Directorate for Planning Growth & Sustainability

Date: 28th May 2021
Your ref: 15/00314/AOP

Re: South West Milton Keynes, Updated Transport Assessment

Figure 1: Junction 2 – Amended drawing showing footway widening

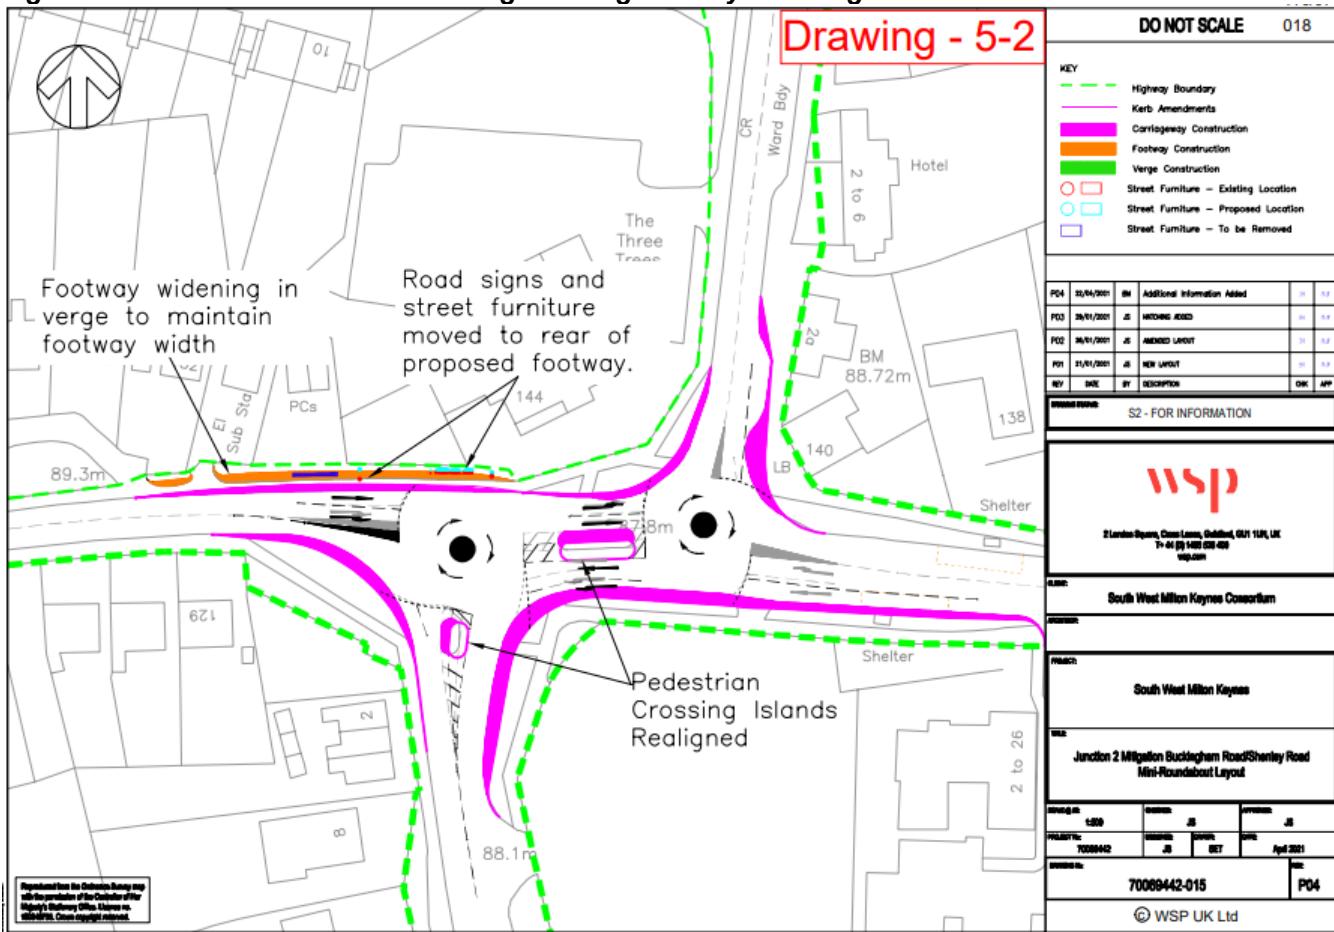
MKC noted the loss of around half the width of the footway on the northern side of Buckingham Road, to the west of the junction to allow the mitigation scheme. This item was raised in the BC highways letter dated 13th April 2021, with the Applicant provided an amended drawing (70069442-15 P04) denoting that conversion of verge to footway to maintain levels of effective footway width that resolves this concern.

Figure 2: Junction 5 – Amended drawing detailing street furniture relocation

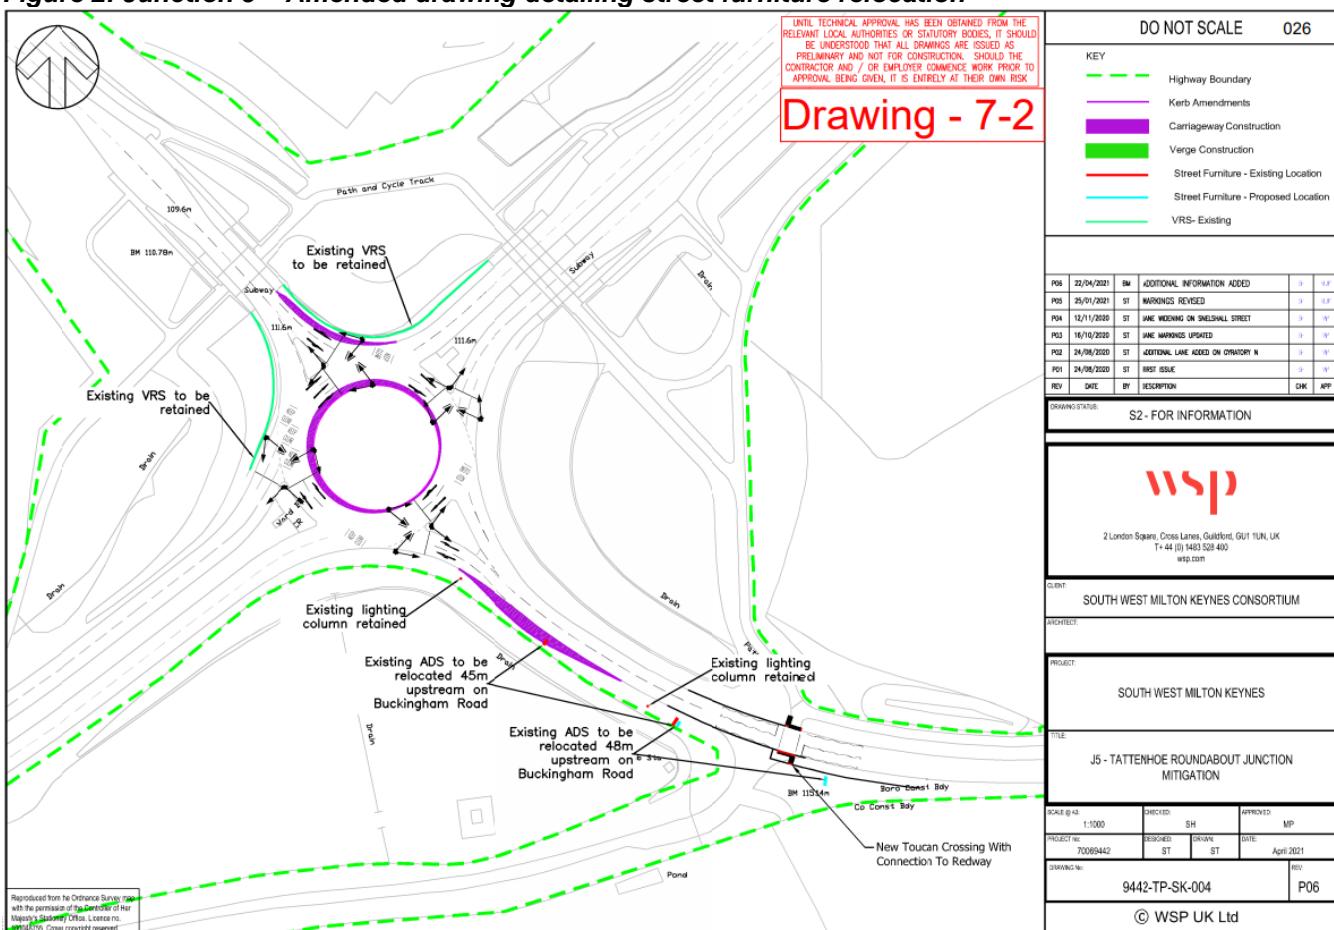
MKC also raised concerns about lack of guide markings, 'Keep Clear' markings, vehicle tracking and relocation of street furniture. The vehicle tracking was raised in the Road Safety Audit with appropriate mitigation to resolve the concerns and it is considered that this could be addressed as part of the s278

detailed design and approval process. Likewise, final lane markings are not considered to be essential elements as part of overall junction feasibility analysis and would be addressed through the s278 process. The use of keep clear markings at part-time traffic signals can be incorporated into the design and are a viable option as set out in the Traffic Signs Manual. In regard to the relocation of street furniture the Applicant has produced an updated drawing (9442-TP-SK-004 P06) to illustrate how the existing street furniture would be relocated appropriately within the scheme.

Figure 3: Junction 5 – Forward visibility to signal heads

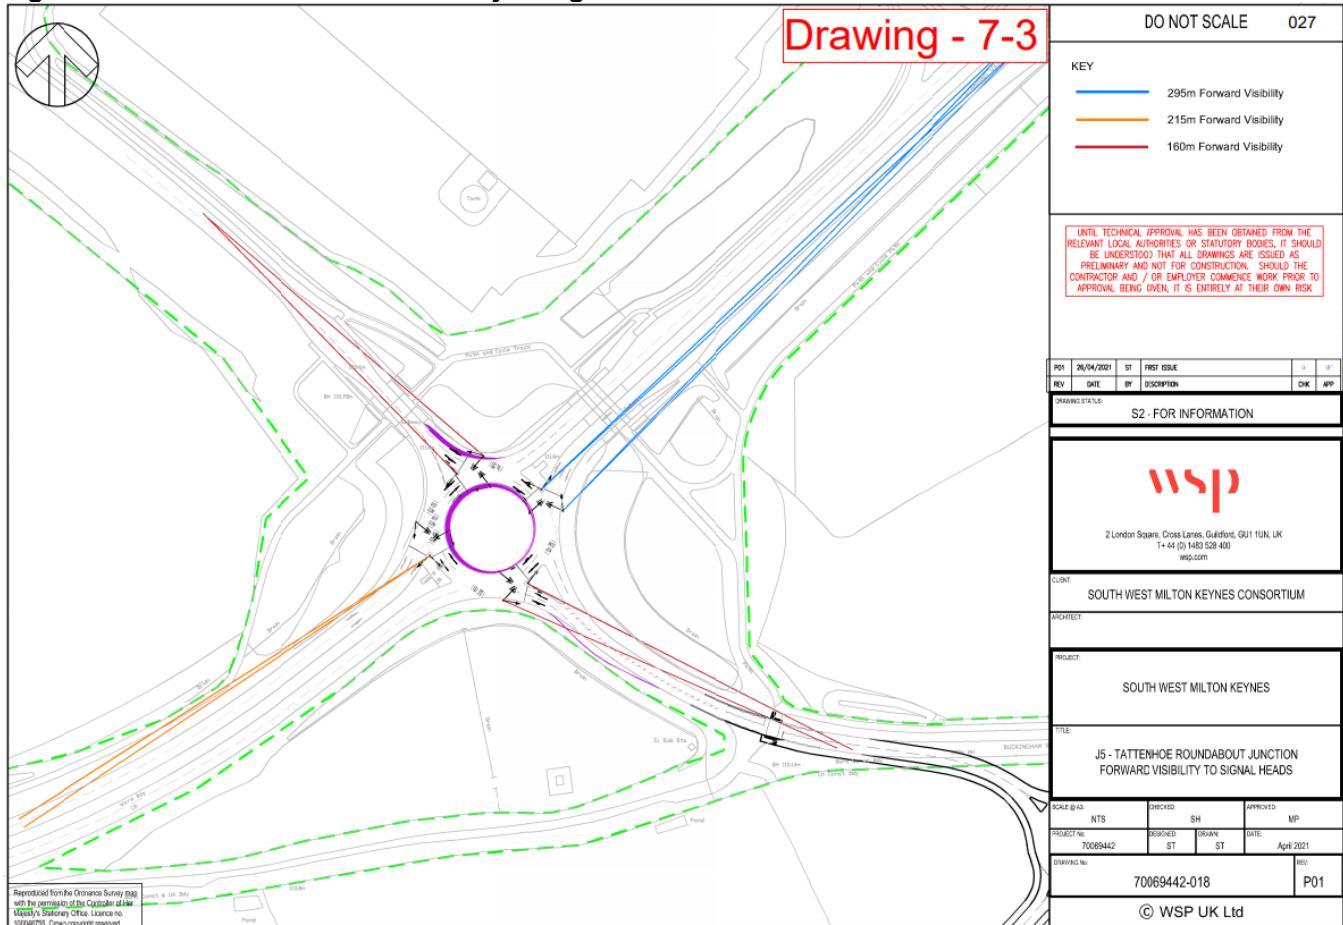
The issue of attaining clear visibility to the new traffic signals was also raised by MKC. The requirement of visibility of the signal heads would be similar requirements for the existing priority-controlled layout and would continue to be so outside of peak times. However, the Applicant has provided forward visibility measurements for all arms at the junction, as detailed on drawing 70069442-018 P01, and this shows the required visibility can be achieved, especially when considering that on Buckingham Road, the presence of the site access roundabout will significantly reduce vehicle speeds on this approach.

Figure 4: Junction 6 – Additional vehicle tracking (drawing 70069442-004-ATR-005 P01)

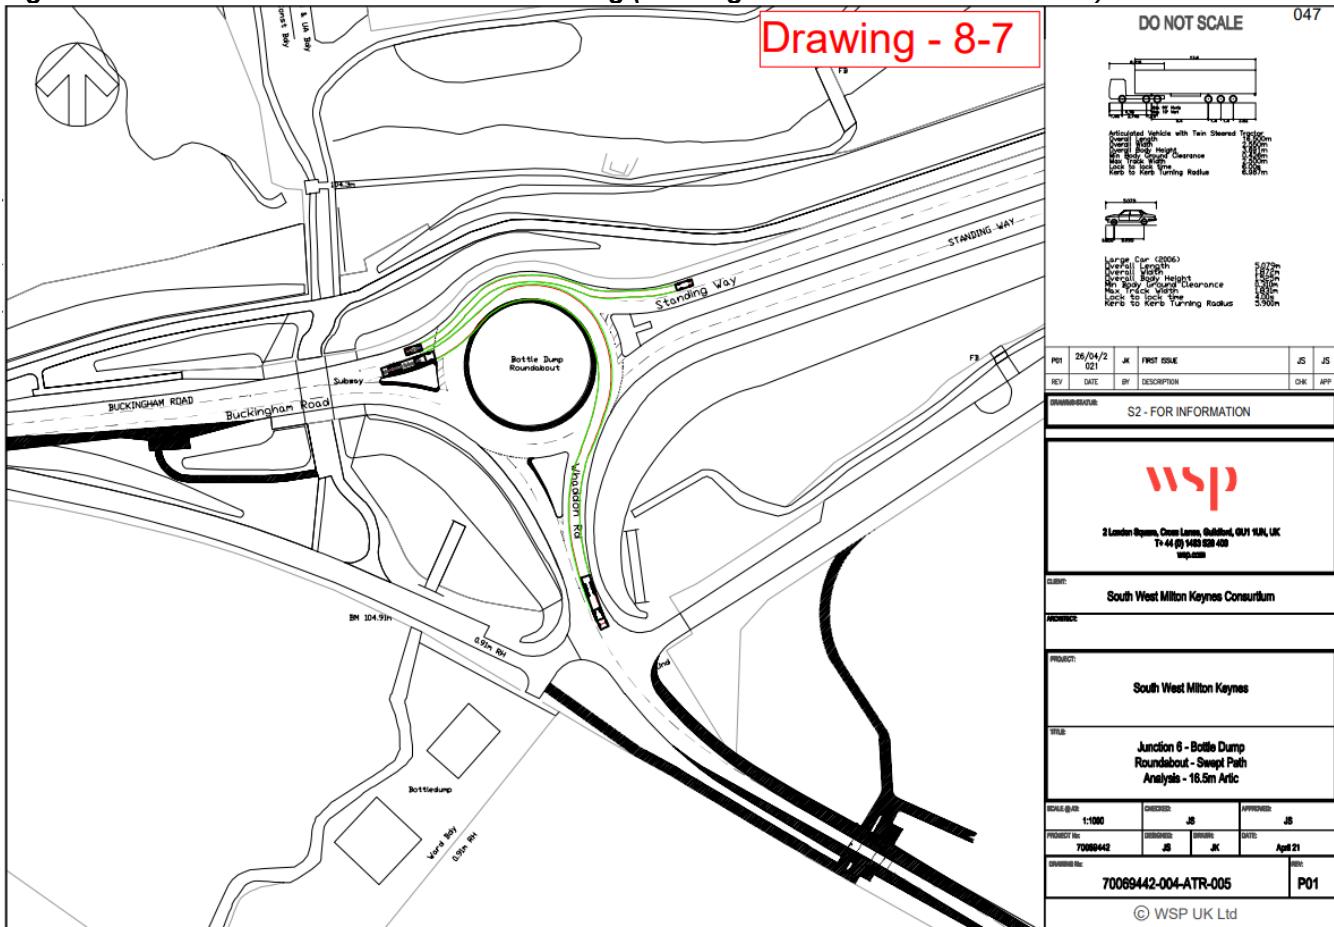
MKC raised concern over potential collisions within the circulatory carriageway and that some movements were missing. The Applicant has provided additional swept path analysis (drawings 70069442-004-ATR-005 P01 and 70069442-004-ATR-006 P01) and these demonstrate that there are no issues with potential vehicle collisions at the junction with the amended geometry.

Figure 6: Junction 12 – Amended drawing detailing location of VRS

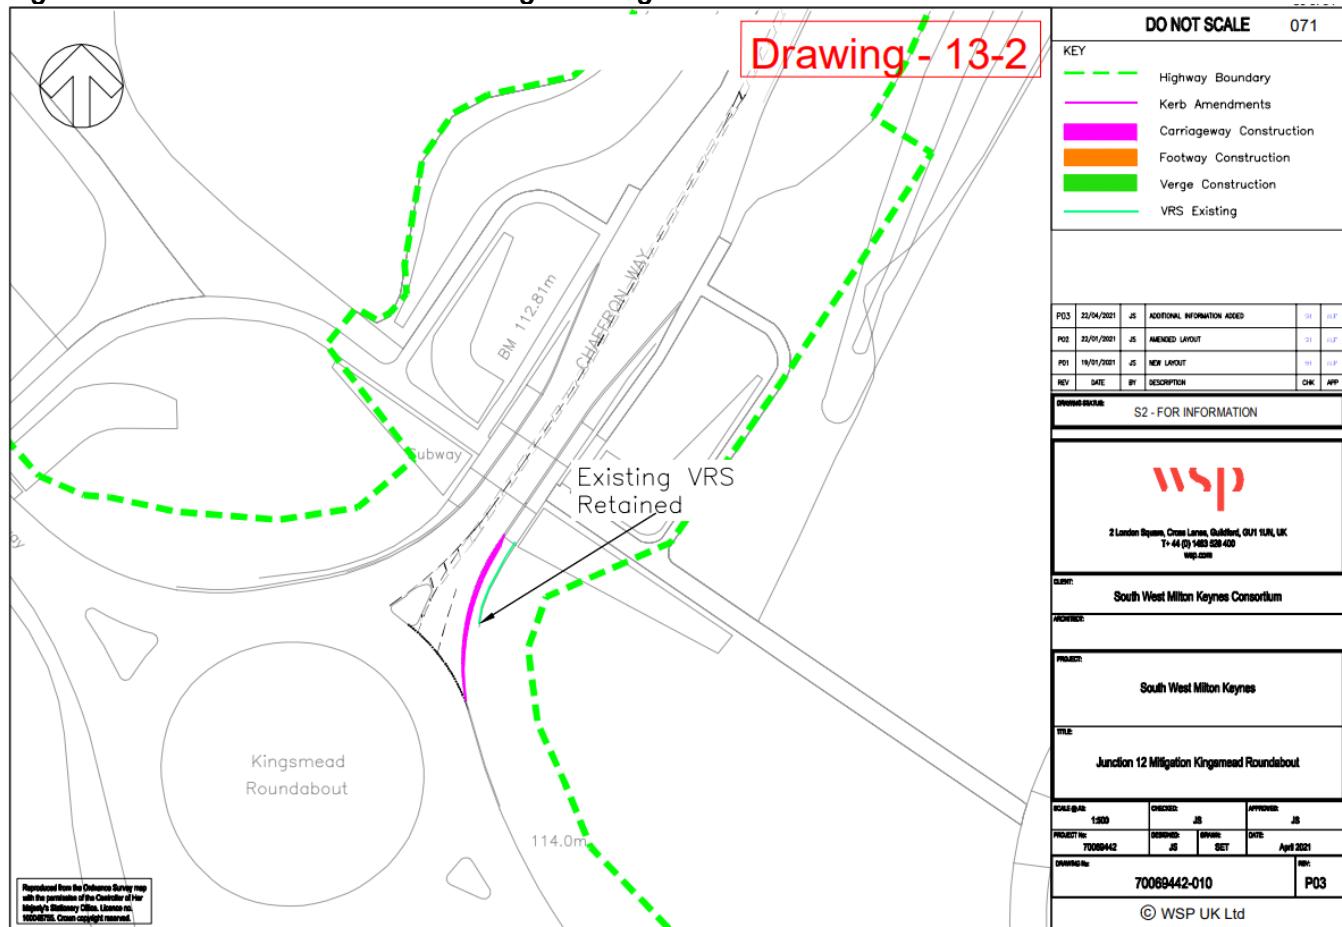
Concern was also raised in relation to the position of the Vehicle Restraint System (VRS) on Chaffron Way and the revised kerbline as its position on the plan appears to be further from the carriageway edge than is the case in reality. The Applicant has produced a drawing showing the location and distance to the VRS (70069442-10 P03) and it has been confirmed that a 1.2m setback from the amended carriageway edge can still be achieved to the VRS which is in accordance with relevant standards.

Figure 7: Junction 12 – Additional vehicle tracking

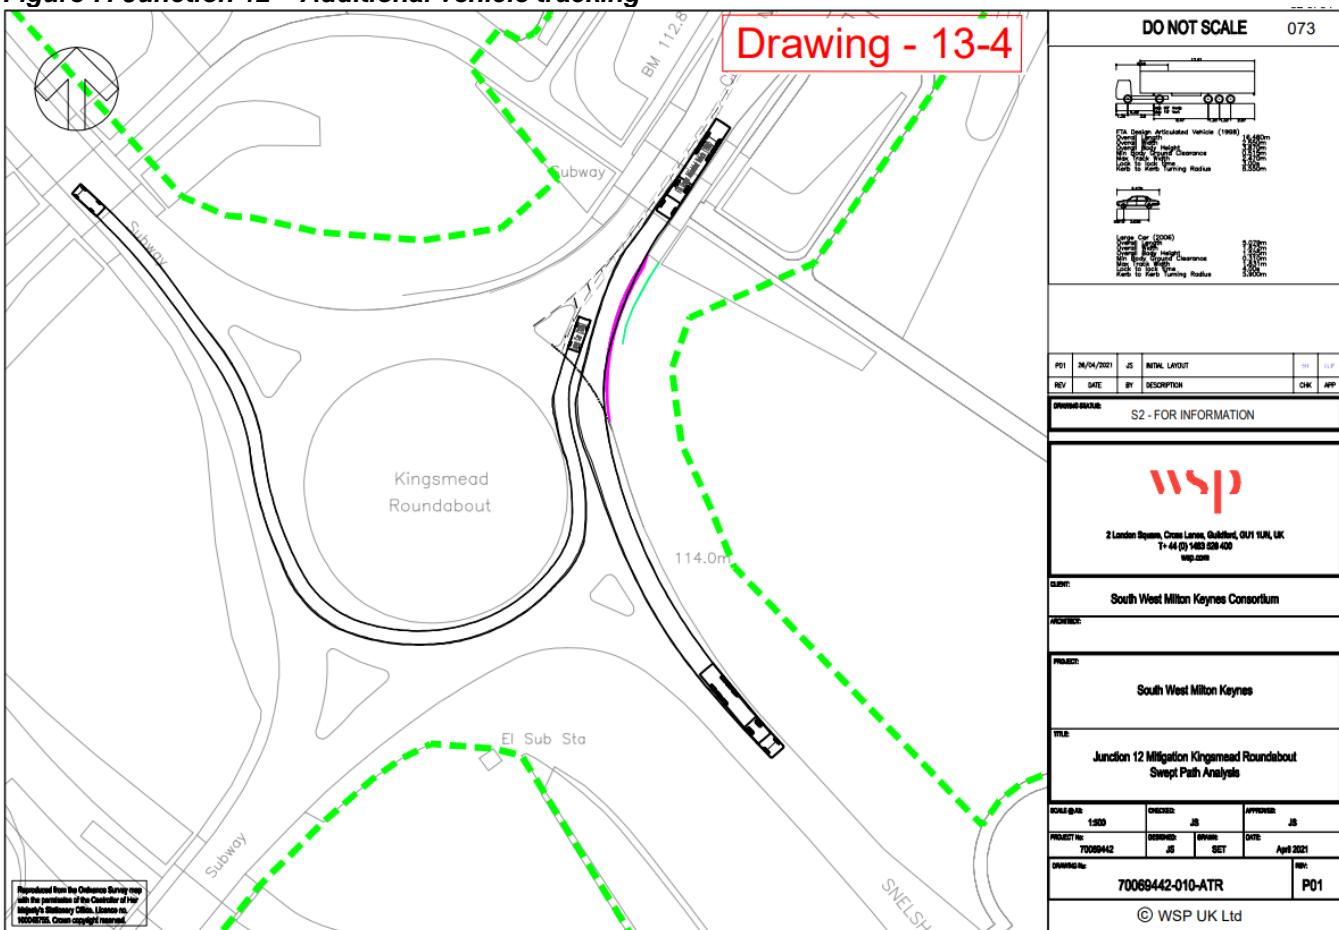
Lastly, a concern was raised over the lack of tracking as the RSA noted the potential for side-swipe collisions on the junction. As detailed in the BC highways previous response on 13th April 2021 the junction is being improved to slightly widen Chaffron Way; this should not cause any issues with vehicle movements with additional space provided to perform required movements. However, the Applicant has produced vehicle tracking for Chaffron Way which is detailed on drawing 70069442-010-ATR P01 and this confirms that there is not issue with conflict in the circulatory carriageway.

Figure 8: Junction 14 – Amended drawing detailing street furniture relocation

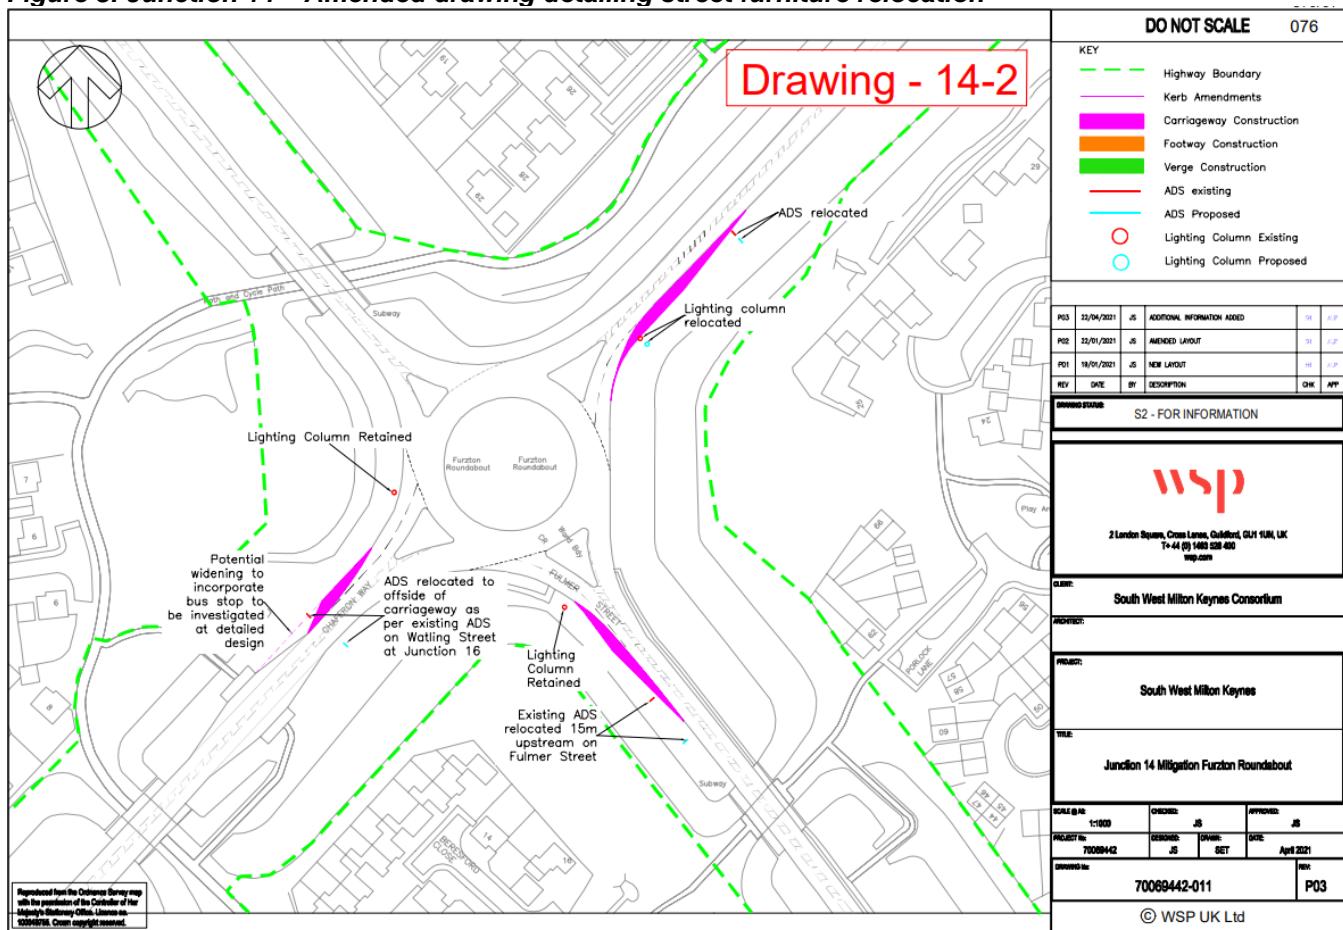
The issue of relocated street furniture was also raised. The realignment / movement of street furniture are considered details that fall within the scope of the later detailed design stage(s) and s278 review and discussions. However, the Applicant has produced an updated drawing to illustrate how the existing street furniture would be relocated within the scheme which does not identify any concerns.

The final point revolves around the area of widened carriageway on the western arm of Chaffron Way which may be obscured from view on approach if a bus is using the bus stop immediately upstream. BC highways do not consider this to be a concern and it was not raised as part of the Road Safety audit. At the same location the comment was provided that consideration should be given to whether the nearside lane would better extend from the bus stop itself (with appropriate markings to control inappropriate use of the bus stop). This is considered to be something that could be considered further at detailed design. As a Traffic Regulation Order would not be required for a Bus Stop clearway the impact of providing appropriate markings would be a design choice only.

Figure 9: Junction 15 – Amended drawing detailing proximity to bridge parapet and lighting column

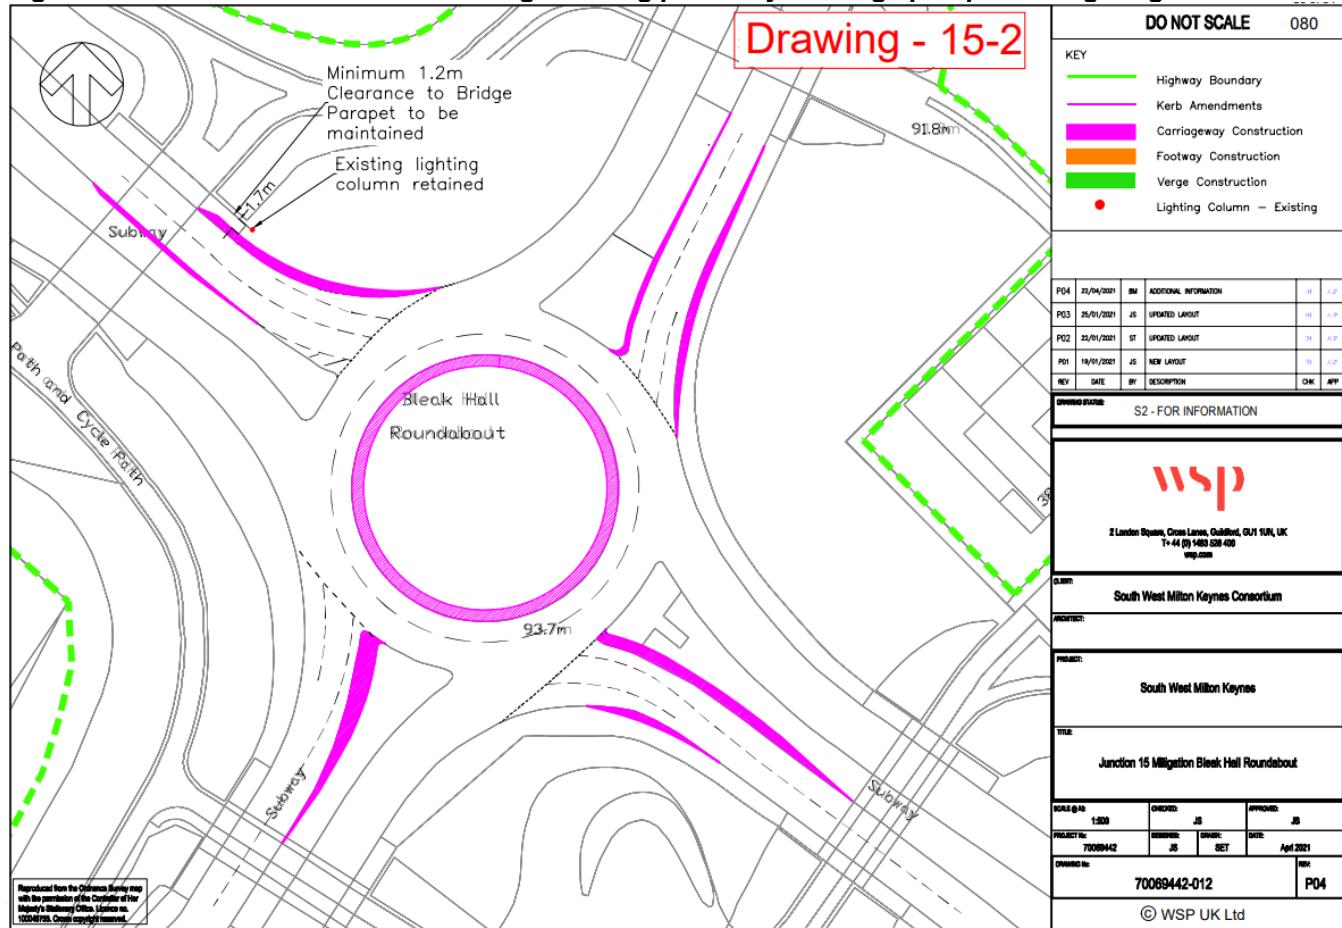
A point was also raised over the widening on the north side of Grafton Street (NW approach arm), which appears to be partially on the subway structure. Also, the distance from the carriageway edge to the railings on the bridge would need to be reduced, as well as the distance to the lighting column in this location. The realignment / movement of street furniture are considered details that fall within the scope of the later detailed design stage(s) and s278 review and discussions, however the Applicant

has produced a revised drawing (70069442-012 P04) that shows an offset of 1.7m (minimum 1.2 m clearance required) is still achievable to the bridge parapet and lighting column.
